UNITED STATES  
DEPARTMENT OF THE INTERIOR  
BUREAU OF LAND MANAGEMENTNM OIL CONSERVATION  
ARTESIA DISTRICTDEC 5 2014  
ArtesiaFORM APPROVED  
OMB NO. 1004-0135  
Expires: July 31, 2010**SUNDRY NOTICES AND REPORTS ON WELLS**  
**Do not use this form for proposals to drill or to re-enter an abandoned well. Use form 3160-3 (APD) for such proposals.****SUBMIT IN TRIPLICATE - Other instructions on reverse side.**

SUNDRY dated 11/12/2014

<b>OPERATOR'S NAME:</b>	<b>BOPCO, L.P.</b>
<b>LEASE NO.:</b>	<b>NMLC-061634B</b>
<b>WELL NAME &amp; NO.:</b>	<b>PLU CVX JV PB 007H 30-015-42639</b>
<b>SURFACE HOLE FOOTAGE:</b>	<b>0531' FNL &amp; 0597' FWL</b>
<b>BOTTOM HOLE FOOTAGE</b>	<b>2310' FNL &amp; 0660' FWL Sec. 29, T. 25 S., R 31 E.</b>
<b>LOCATION:</b>	<b>Section 20, T. 25 S., R 31 E., NMPM</b>
<b>COUNTY:</b>	<b>Eddy County, New Mexico</b>

BOPCO  
Project: South East New Mexico

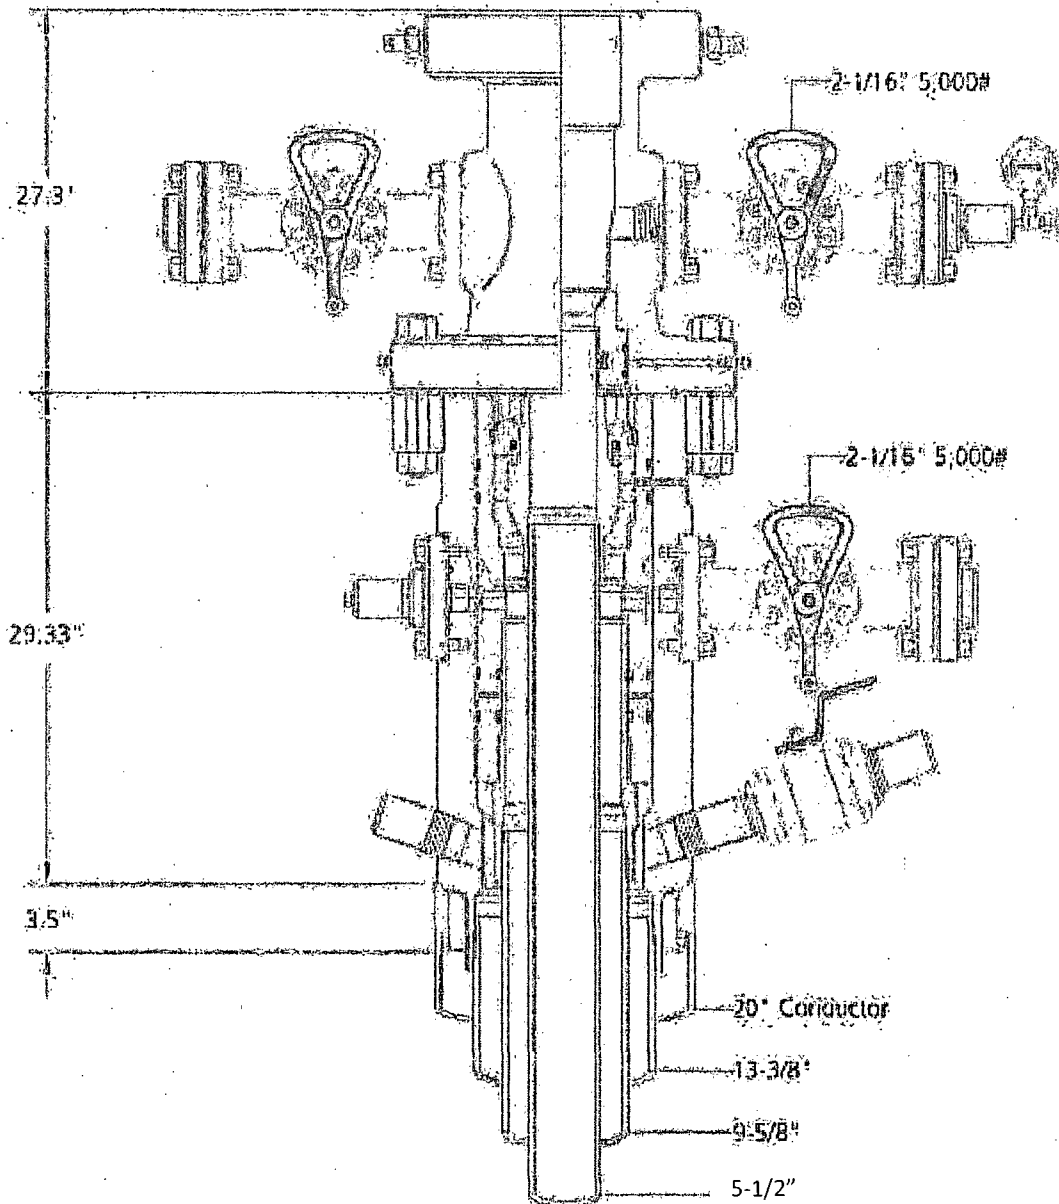
We will also change our wellhead set up from a Cameron MBS system to a Cameron MB-ND system.

3. **Operator has proposed a multi-bowl wellhead assembly. This assembly will only be tested when installed on the surface casing. Minimum working pressure of**

- a. Wellhead shall be installed by manufacturer's representatives, submit documentation with subsequent sundry.
  - b. If the welding is performed by a third party, the manufacturer's representative shall monitor the temperature to verify that it does not exceed the maximum temperature of the seal.

- c. Manufacturer representative shall install the test plug for the initial BOP test.
  - d. Operator shall perform the intermediate casing integrity test to 70% of the casing burst. This will test the multi-bowl seals.
